Prime Contract Change Order #002: CE #004 - Exterior Windstorm Rated Doors

CE #004 - Exterior Windstorm Rated Doors

PROJECT: **Levy County Development**

RE: New Exterior Windstorm Labeled Frames

EXTERIOR FRAMES

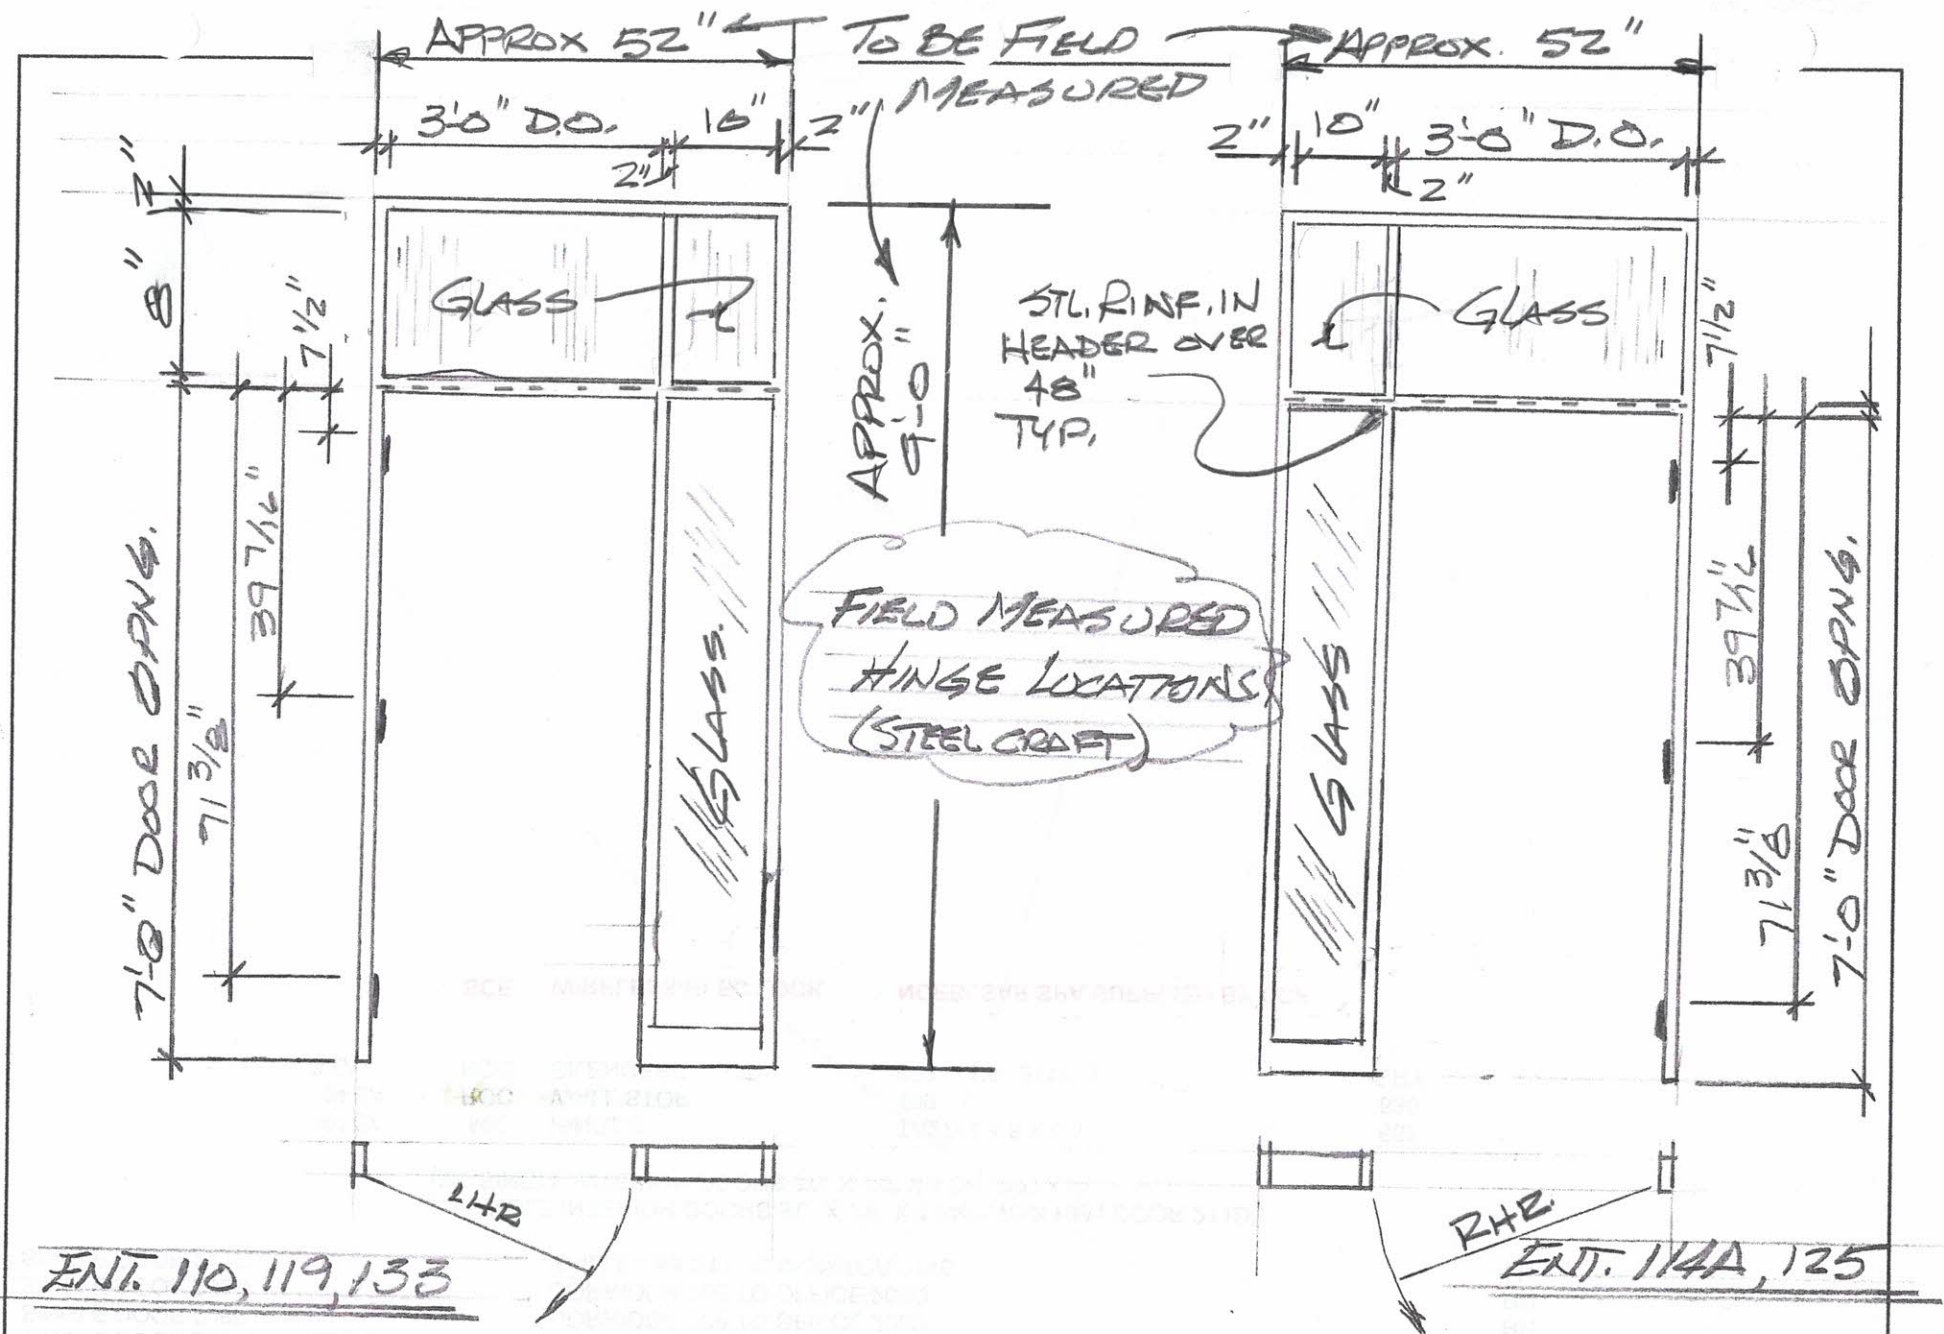
- 1) Elevation of new Windstorm Frame. Please note that the strike Jamb Mullion must run thru the transom Area to the header. Anchor bolts for the masonry are included. No Bituminous coating is included. Frames are 16 Ga Galvanized, welded materials with Glazing bead cut to fit in glass areas. The frame Pricing does not include panels for the transom areas. See additional price for panels. No Installation or glass is included.
- 2) Copies of the Florida Windstorm Approvals for the frames (FL1592) and the Data that approves The Schlage Lock CO-100-CY for use on these openings (FL12400). (I previously stated that they could not but the attached Data says you can so I was incorrect in my Submittal Statement.

5 Each Sidelite frames per attached sketch

DOOR CONFIGURATIONS 1-4

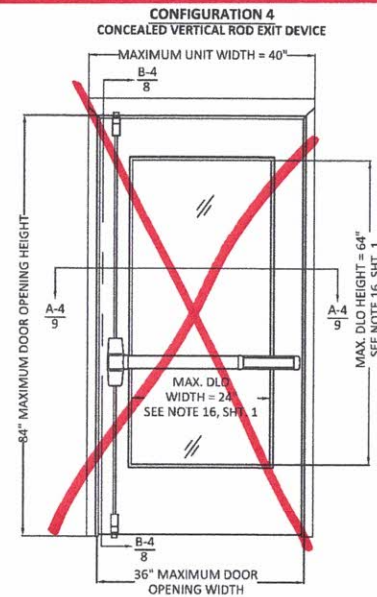
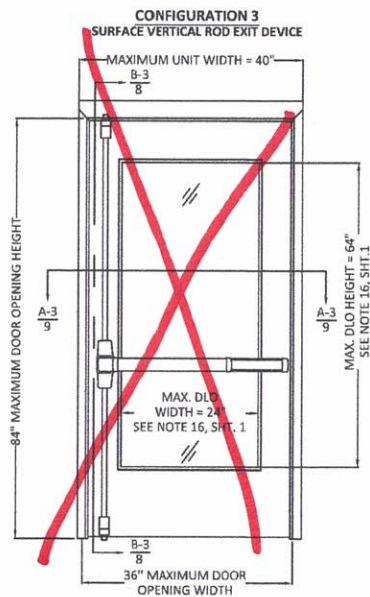
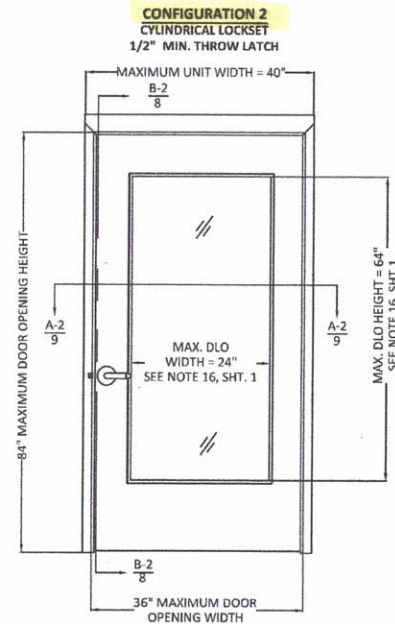
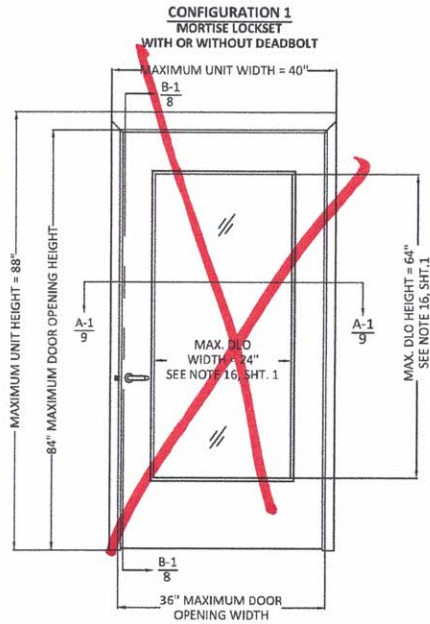
MAXIMUM
GLASS SIZE
SHOWN.
WE HAVE
A 6"x30"
LITE.
